# Engineering Change Notice

The following table contains a list of engineering changes that are not reflected in the Tsi381 Evaluation Board Schematics.

**Table 1: ECN for E2000\_AS001\_05 (Board order number Tsi381-RDK1 V2.0)**

# Tsi381 Evaluation Board Schematic

TITLE :			
<b>PCI SLOT 2</b>			
SIZE	DRAWING NUMBER :	Version:	DESIGNER :
<b>C</b>	60E2000_SC001_03	1.0	
LAST MODIFIED DATE :			SHEET
7-25-2007_15:14			9 OF 15

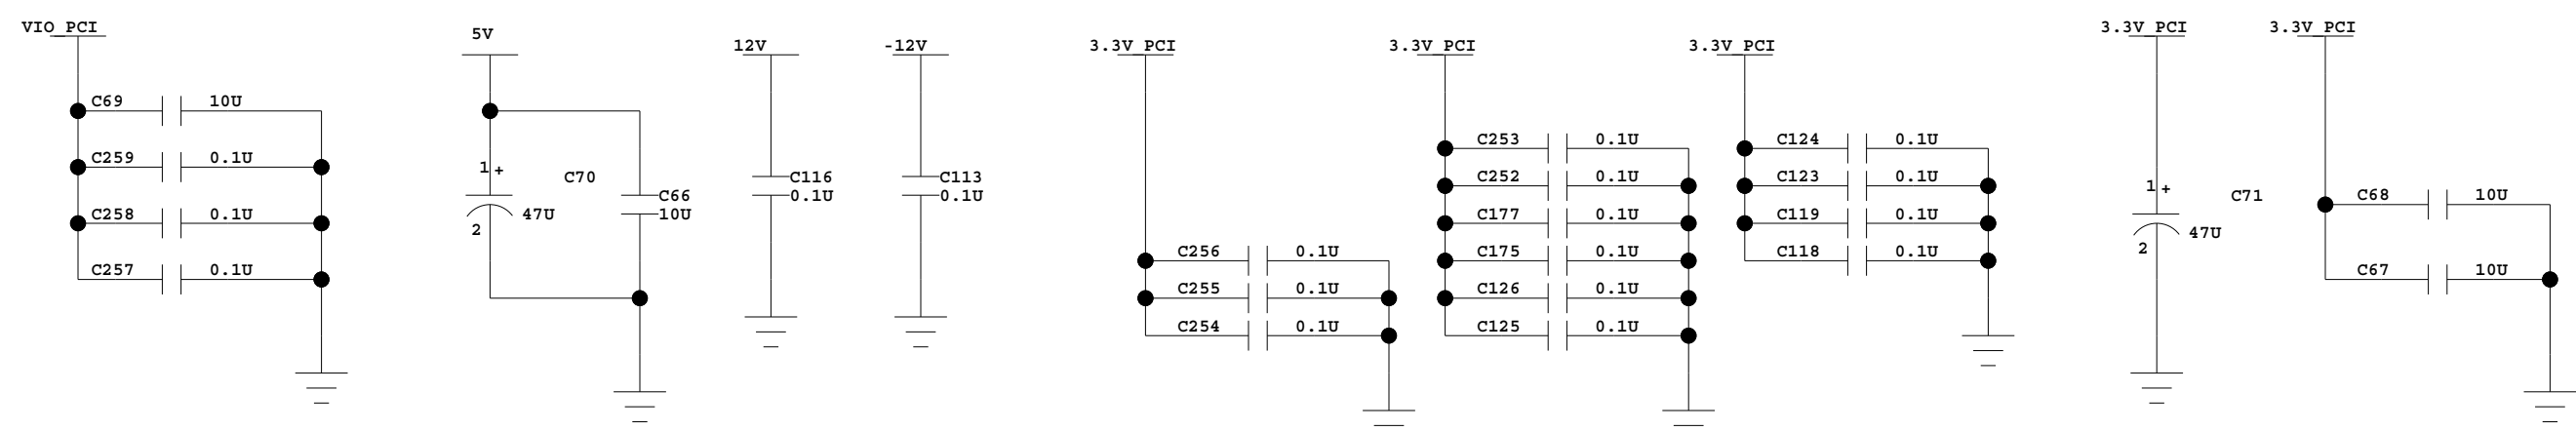
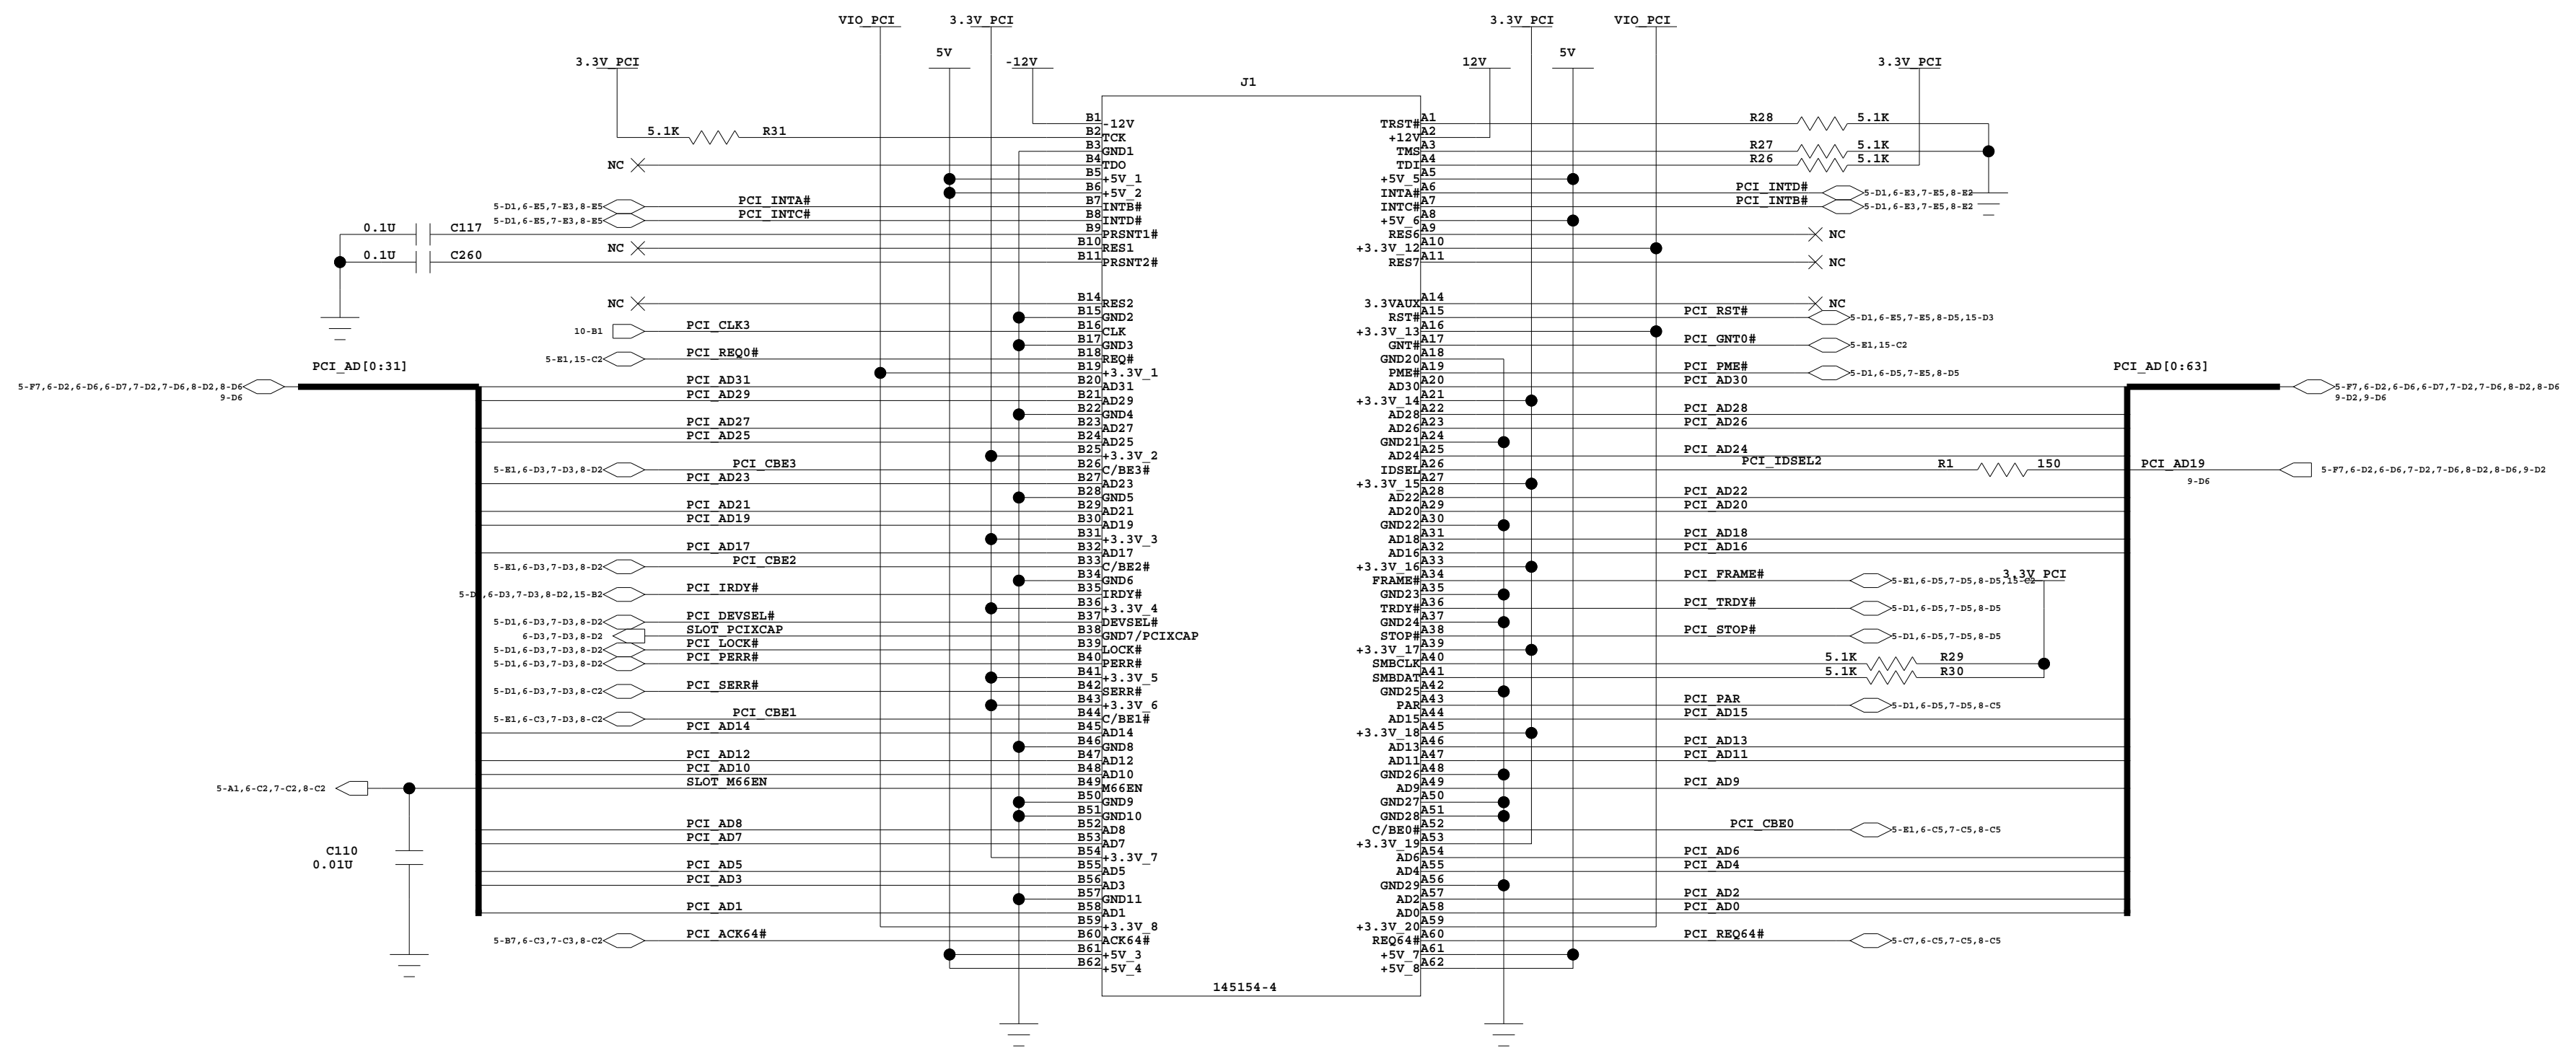
No.	Item(s)	Original	Change To
1	Tsi381 Device	Tsi381-66ILZ1	Tsi381-66ILZ2
2	3.3Vaux on J1, J2, J36, J37 <sup>a</sup>	No connection	Short pin A14 (3.3Vaux) to pin A16 (VIO_PCI) with 0-Ohm (0603) resistor

a. 3.3Vaux does not provide power to plug-in cards when the system is powered down.

No.	Item(s)	Original	Change To
1	Tsi381 Device	Tsi381-66ILZ1	Tsi381-66ILZ2 <sup>a</sup>
2	3.3Vaux on J1, J2, J36, J37 <sup>b</sup>	No connection	Short pin A14 (3.3Vaux) to pin A16 (VIO_PCI) with 0-Ohm (0603) resistor

b. 3.3Vaux does not provide power to plug-in cards when the system is powered down.
